RE: Reponses to Comments
Dutch Bros Coffee
2366 Feather River Boulevard, Oroville, California, 95965
Our Job No. 22036

We have revised the plans and technical documents for the above-referenced project in accordance with your comment letter dated January 13, 2022. Enclosed are the following documents for your review and approval:

#### Marked up Plans with Comments

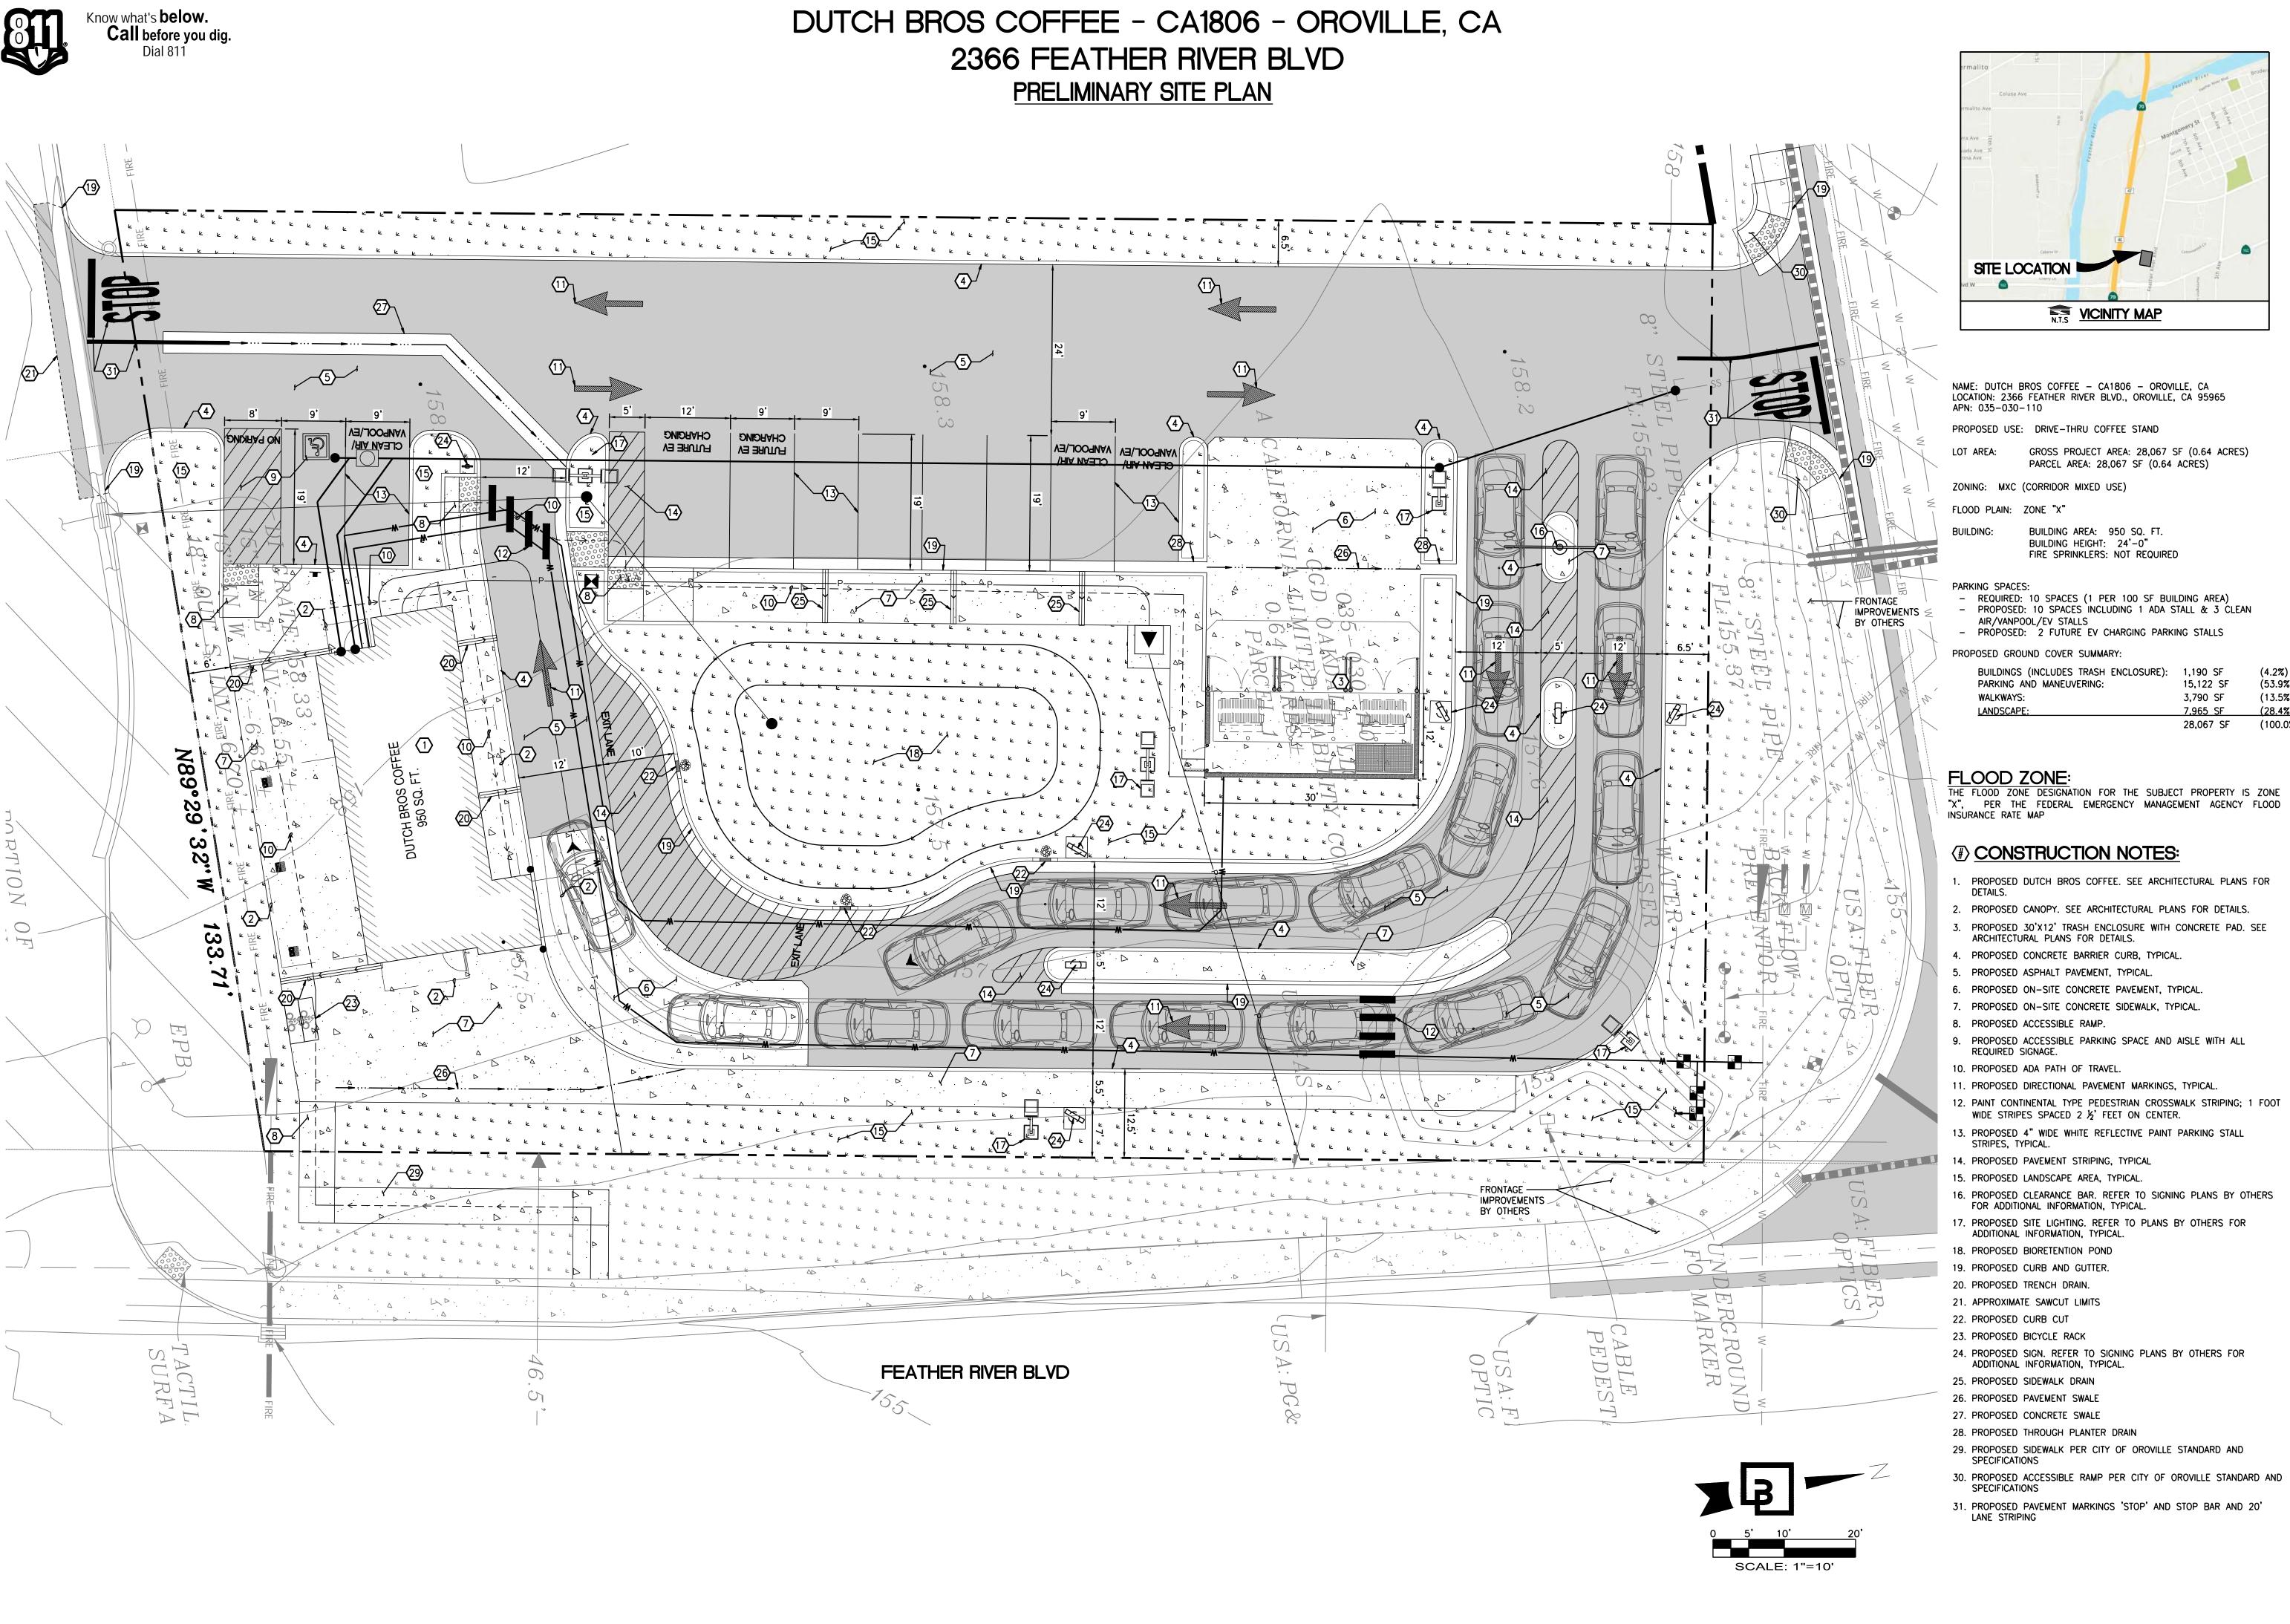
Consider concrete curb paving for runners

o Curb, gutter, sidewalk required along access road at least to driveway

ADA Curb Ramp Needed

Confirm sidewalk along entire frontage

Need to show landscaping here

Need to show landscaping here

**Response**: A 60-inch runners walk is already provided.

**Response**: Sidewalk along Feather River and north side access road is to be installed and permitted by others.

**Response**: ADA ramps were added to northern driveway. Landlord's engineer is waiting for geometrics for driveway at Feather River Boulevard and will add ADA ramps once geometrics are received.

Response: Sidewalk added along Feather River. Sidewalk to be permitted by others.

**Response**: Landscaping shown along the right-of-way of Feather River and side access road is to be permitted by others.

**Response**: Landscaping shown along the right-of-way of Feather River and side access road is to be permitted by others.
